CITY OF SAN ANTONIO

Re: Culebra Market Shopping Center POADP # 656

The City Staff Development Review Committee has reviewed the Culebra Market Shopping Center Preliminary Overall Area Development Plan # 656. Please find enclosed a signed copy for your files. Although your plan was accepted, please note the following:

CULEBRA MARKET SHOPPING CENTER
PRELIMINARY OVERALL AREA DEVELOPMENT PLAN
POADP NO. _____

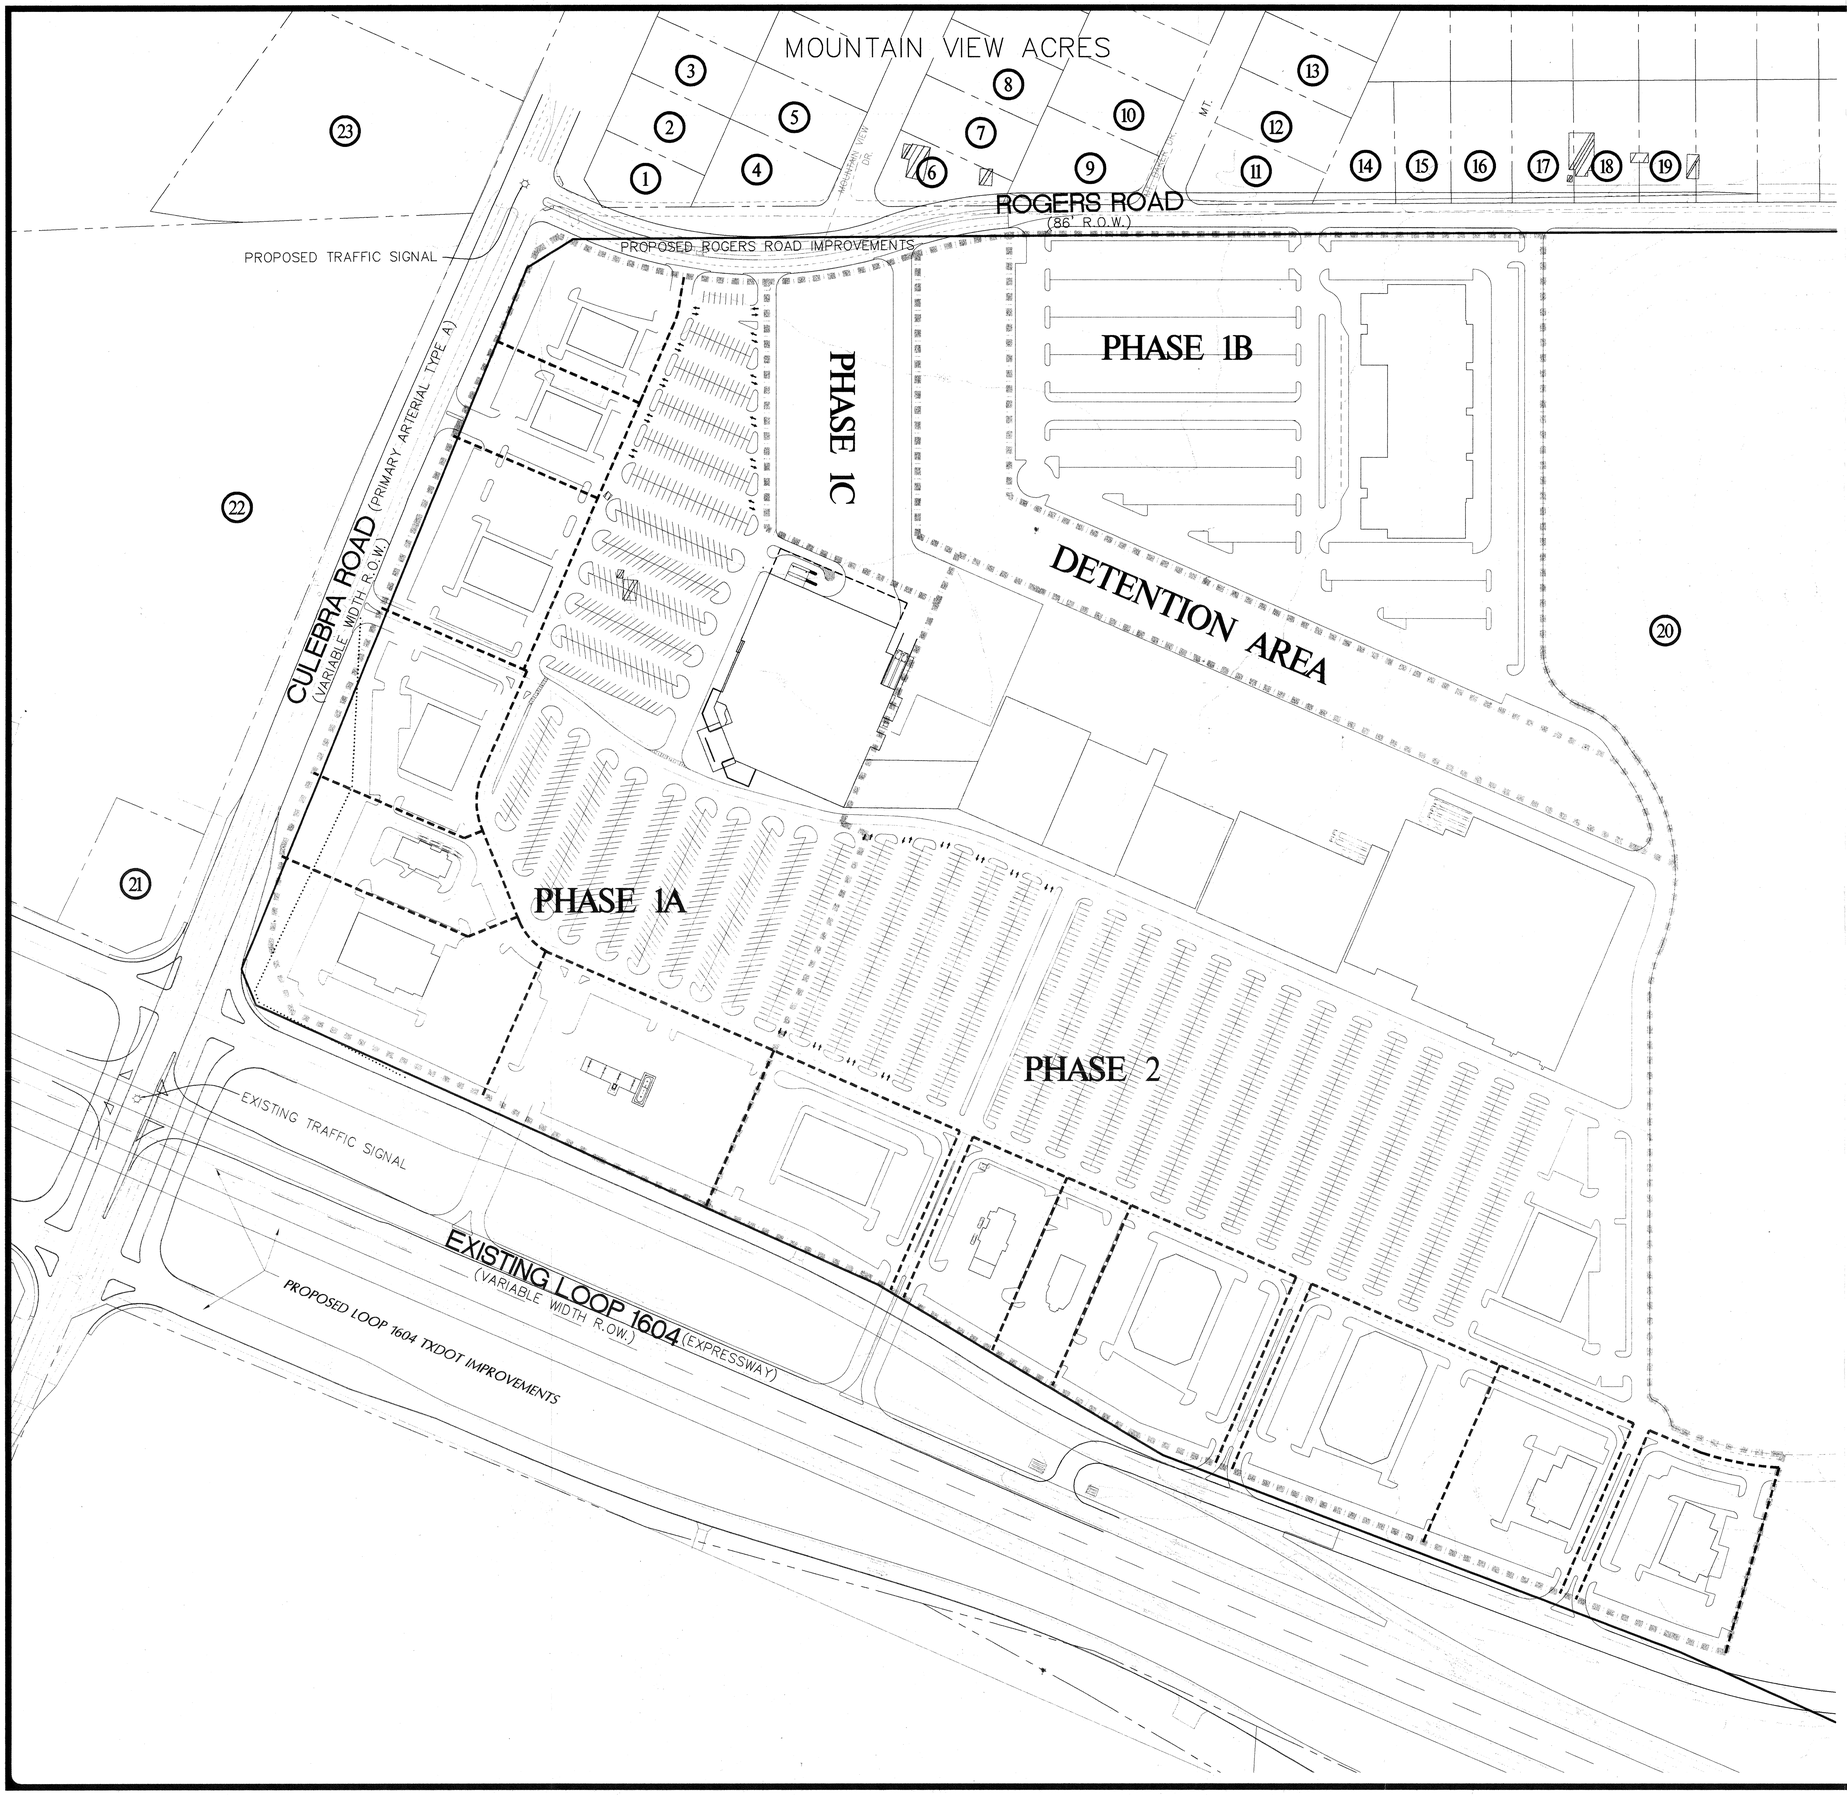
- Based on the topography, a Flood Plain Study and drainage review will probably be required during the platting process
- In consideration of public safety and convenience, excessive grades by reason of topography should be avoided in street layouts and arrangements.
- Access and R.O.W. issues along State facilities will need to be resolved with the Texas Department of Transportation (TXDOT). For information about these requirements you can contact TXDOT at 615-5814.
- This development will need to comply with tree preservation ordinance #85262. For information about these requirements you can contact Building Inspections at 207-7102.
- It will be expected that you will plat all of the property depicted in your POADP, to include: floodpains, drainage areas and open space.
